**FINDINGS OF FACT  
FLORENCE PLANNING COMMISSION  
Exhibit "A"**

**Public Hearing Date:** August 9, 2016  
**Date of Report:** August 2, 2016  
**Application:** PC 16 09 DR 02

**Proposal:** A request for a phased design review to construct an office building in the Mainstreet District

# Options Counseling & Family Services - Florence Expansion Phase 1 of 2 Community Development Design Review Application

1 CIVIL SITE GRADING PLAN - PHASE 1  
C3.1 SCALE: 1" = 10'-0"

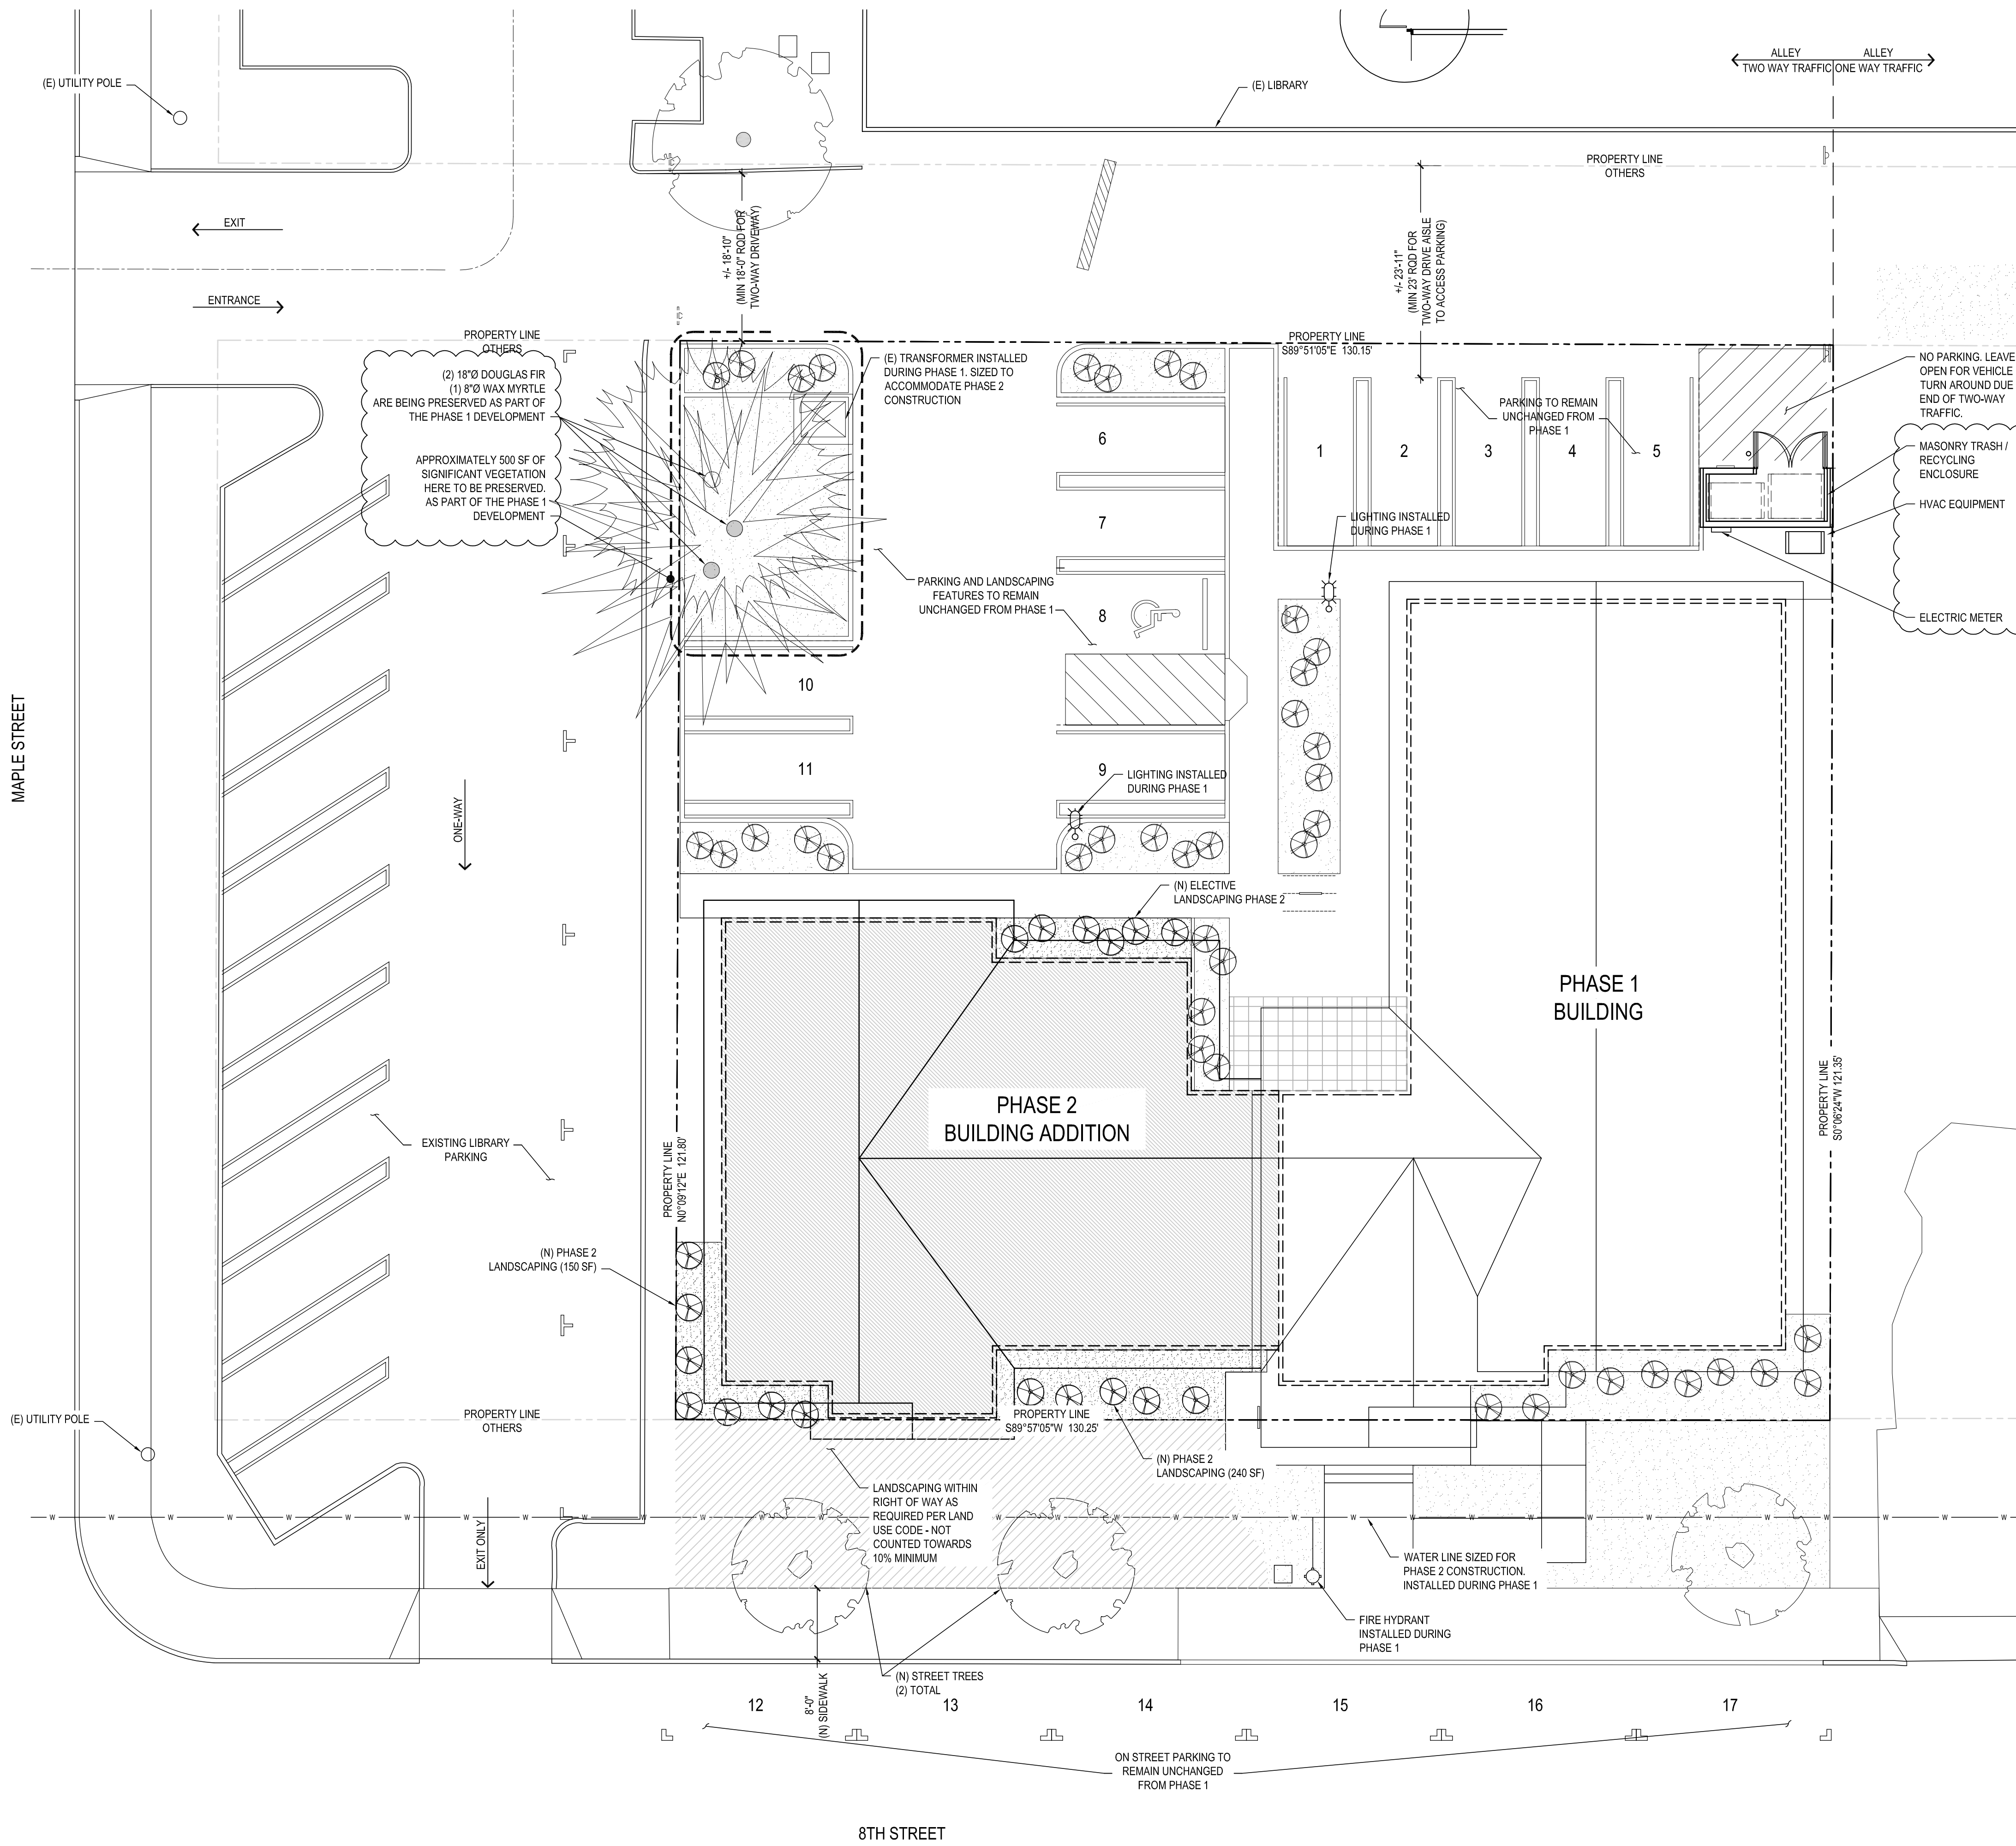
The applicant proposes to install a new 8" water main within the 8<sup>th</sup> St. right-of-way. Stormwater plans were submitted that include collection of parking lot drainage into catch basins and water quality pre-treatment within on-site planters and overflow into infiltrators within the 8<sup>th</sup> St. right-of-way. Sewer is available within the 8<sup>th</sup> St. right-of-way. Prior to building permit issuance or construction of utilities the applicant shall apply for and receive approval of right-of-way permits from the Public Works Director for the stormwater, sanitary sewer and water improvement and connection plans. A private use of a public right-of-way permit is required for the stormwater infiltrators within the 8<sup>th</sup> St. right-of-way. **(Condition 9)**

1 BUILDING SITE PLAN - PHASE 1  
B1.1 SCALE: 1" = 10'-0"

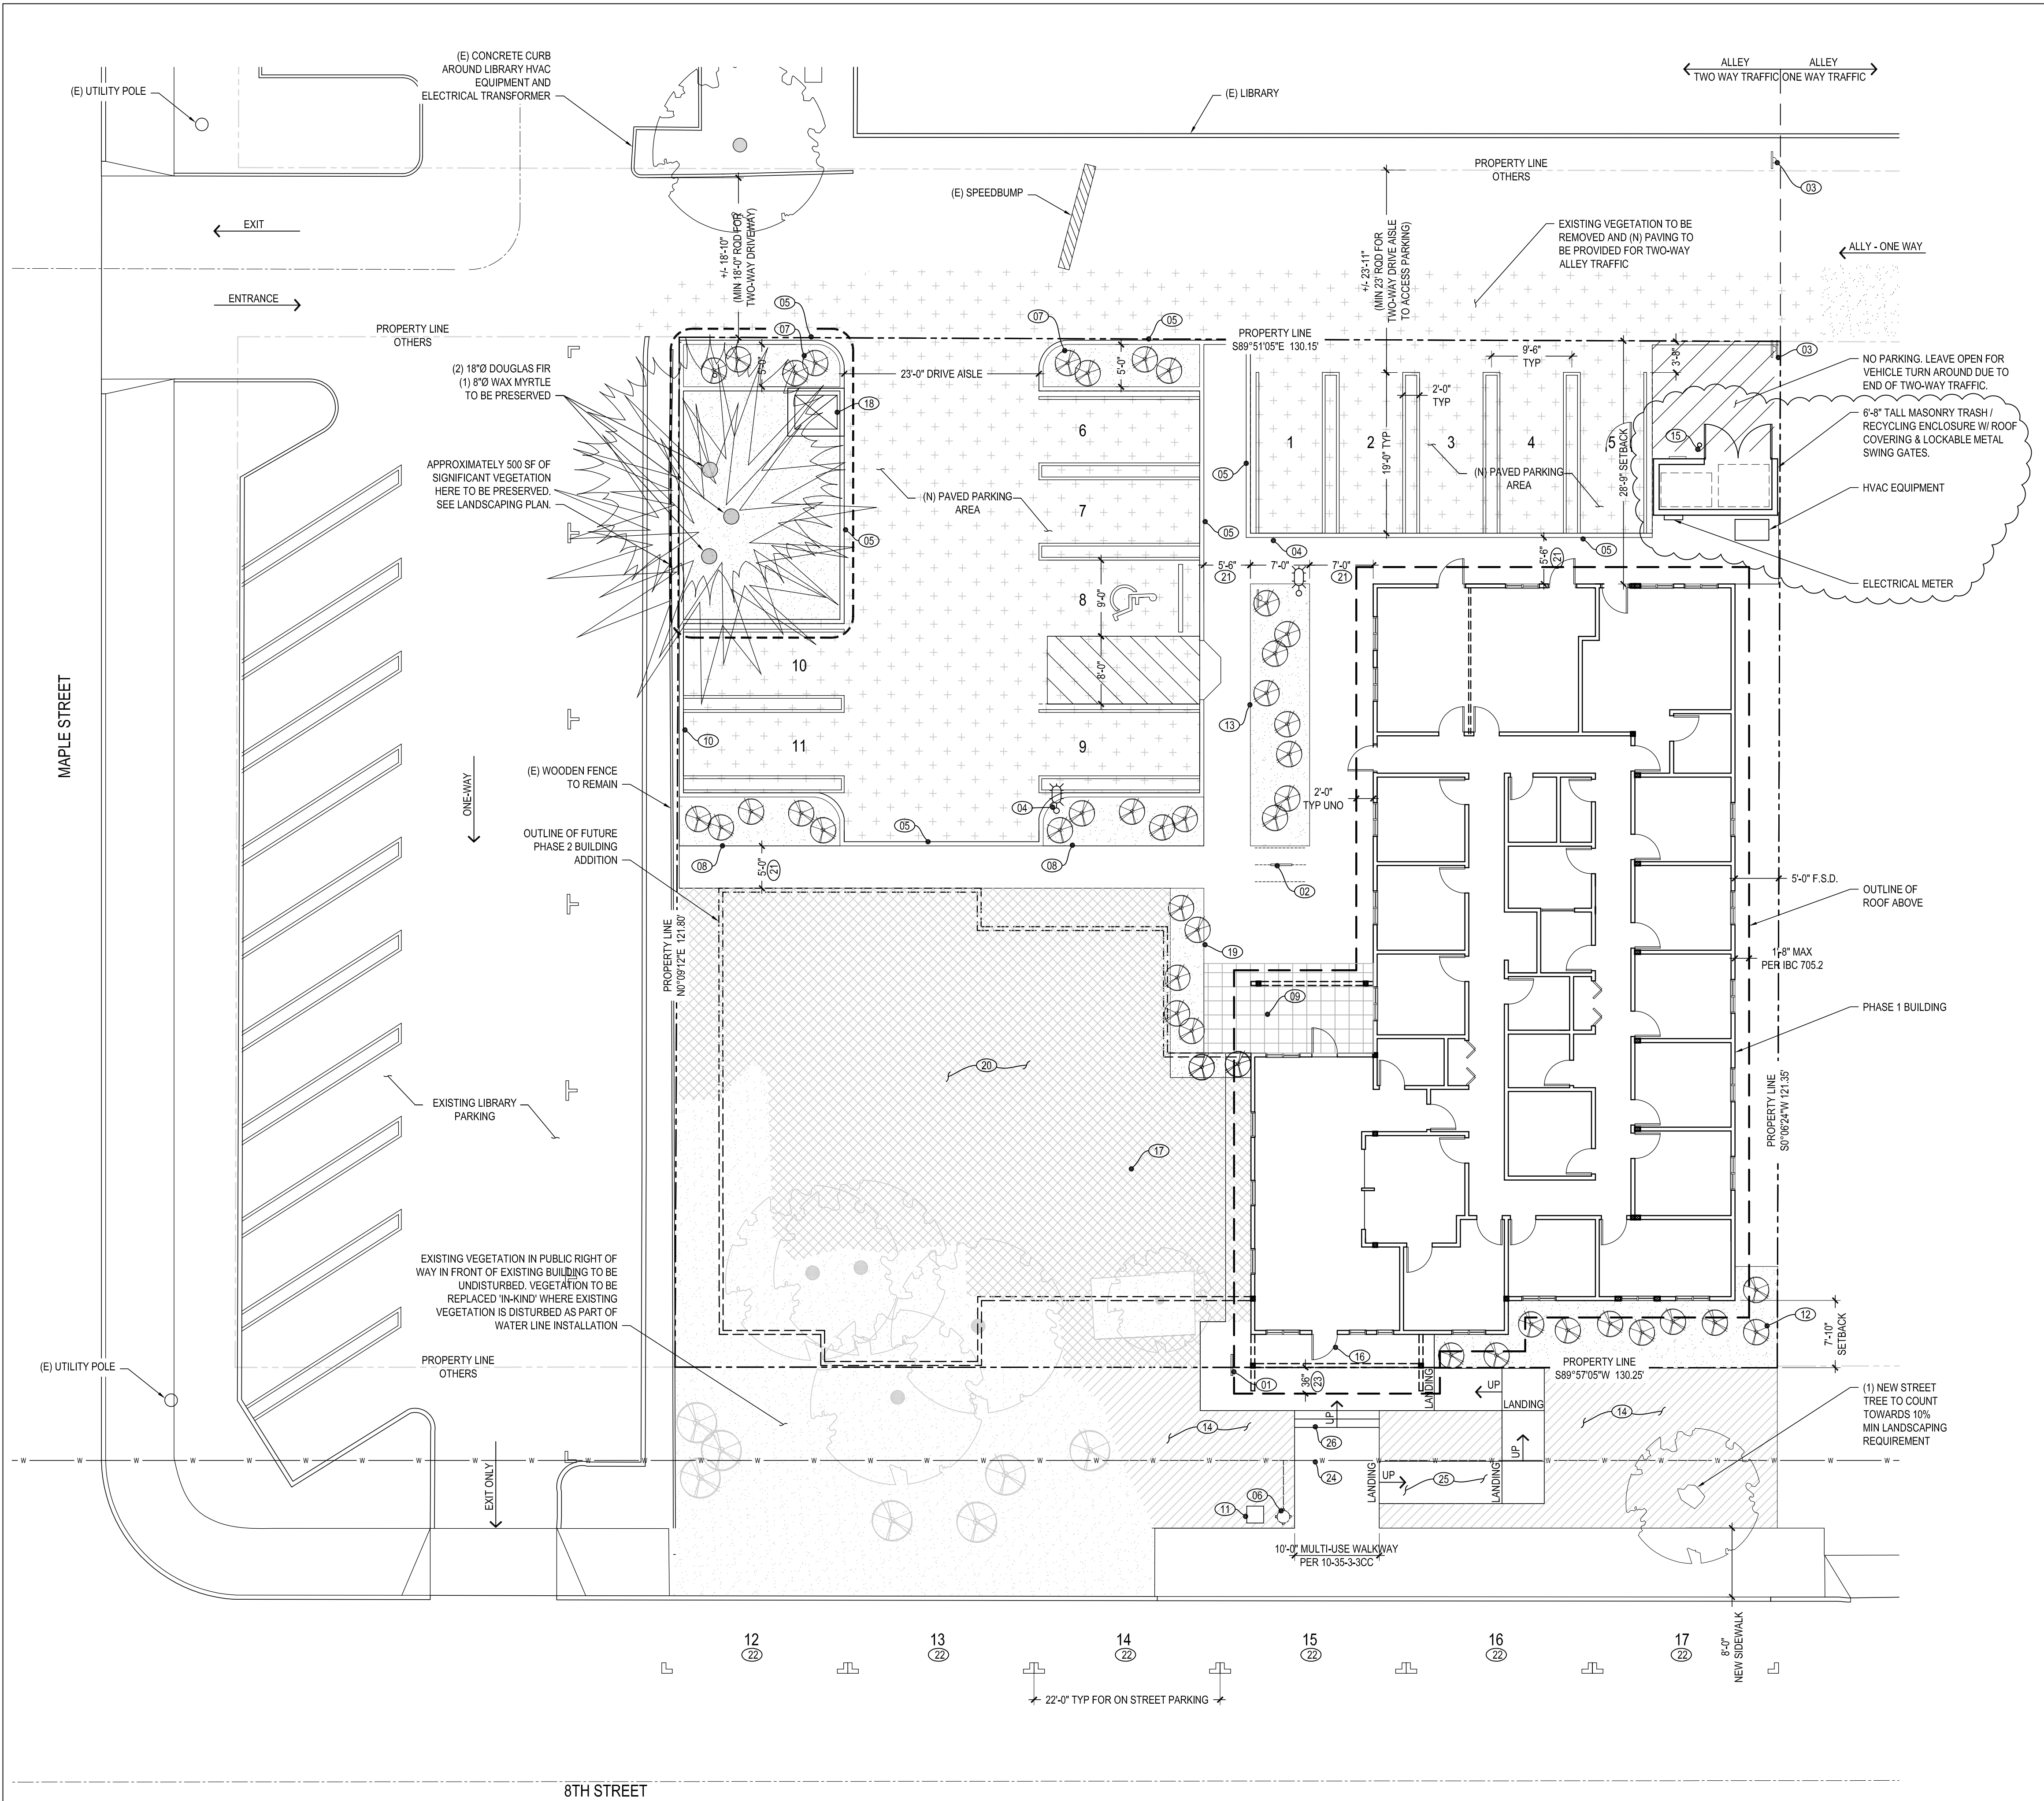
The site plan illustrates 6" high curbs along the western interior property line and along the northern landscape planters adjacent to the alley. The vehicular access aisle turnaround for the eastern parking lot does not illustrate a curb along the eastern property line. A curb of not less than six inches in height shall be placed along the eastern property line abutting the turn-around area to prevent motor vehicle encroachment onto the adjacent private property. **(Condition 4)** Five foot wide landscape islands are proposed along the northern property line on either side of the western parking lot area abutting the alley. The remainder of the parking area includes ingress and egress area. Except as conditioned above, these criteria are met.

The site plan illustrates a trash enclosure in the north east corner of the property within the rear and eastern side yards. Construction will include a 6'-8' high masonry fence with a low relief roof covering. Service to the fence is from the alley. The gates are proposed to be metal with no additional specificity. If the gates to the trash enclosure are chain link they shall be slatted. **(Condition 8)**

All of the Phase 1 building's six exterior doors have exterior access onto a 5' wide or greater sidewalk. The two stormwater planters south of the parking lot shall ensure the required 6" wide planter wall does not encroach into the required 5' wide pedestrian access along the northern building wall. ADA access is available to the back door and also to the front door via a pathway within the 8<sup>th</sup> St. right-of-way. All on-site parking areas have pedestrian access to the building. On-site circulation is provided.

*The trash enclosure walls will be 6'-8" tall and constructed out of 8" masonry block. The enclosure will have a low sloping metal roof. Access to the enclosure will be through two lockable, metal swing gates that face the alley. See clouded revisions on Sheet B1.1 Site Plan Phase 1. Trash Enclosure roof runoff to be directed to Stormwater planter.*

*See clouded revision to keynote 08 on B1.1 Site Plan Phase 1 that clarifies the area of the two small stormwater planters. Each of the two planters is 107 SF in area.*
